Company	Trenz Electronic GmbH
PCN Number	PCN-20221115
Title	TEI0001-03 to TEI0001-04 Hardware Revision Change
Subject	Hardware Revision Change
Issue Date	2023-01-17

2.8 #7 Updated components from library.

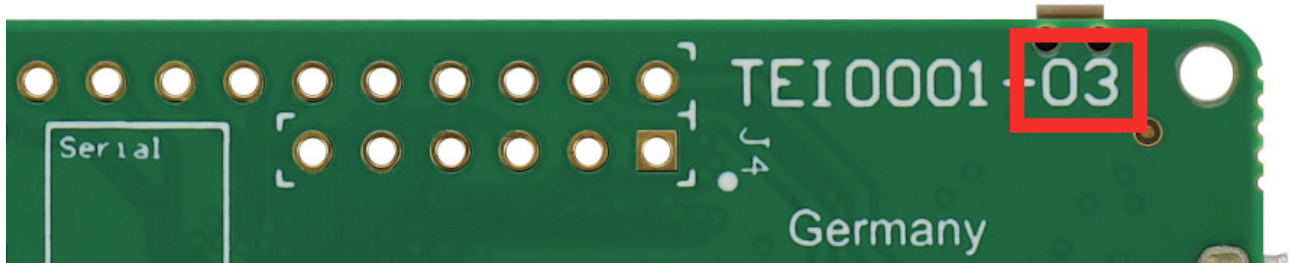
Type: Schematic Change

Reason: Use latest component data.
